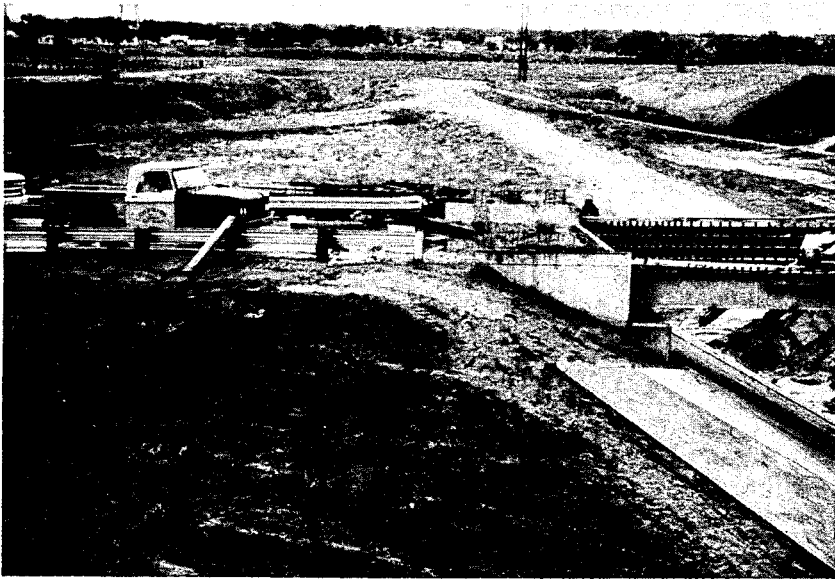
This is a very interesting picture, because in contrast with what we saw in Missouri a few minutes ago, where there was almost no rail in place, they are just starting to put the rail up ahead of some of the structures that have been open 6 or 8 months. Here they built the rail and finished it off before they even got a floor on the bridge. So this is 186° opposite, apparently, in their thinking.

There is no—I would point out, this bridge is under construction today; there is no connection at all between these. [Indicating.]

Mr. CONSTANDY. The picture certainly suggests that two different groups of people design and construct the elements which are to work together and function together to afford safety to the motorist. The guardrail is installed and finished ready to be open to traffic and the parapet at the end of the bridge has not even been built yet.

Mr. CRAMER. Well, Mr. Prisk, I understand the AASHO design standards which you indicate were adopted about that time provide, on page 29, as follows:

To afford maximum protection and to develop the full strength, the rail—

on the approaches to structures must be attached securely to the structure and provide a relatively smooth configuration on the traffic side.

This would be in violation of that regulation over AASHO standards at the present time; would it not?
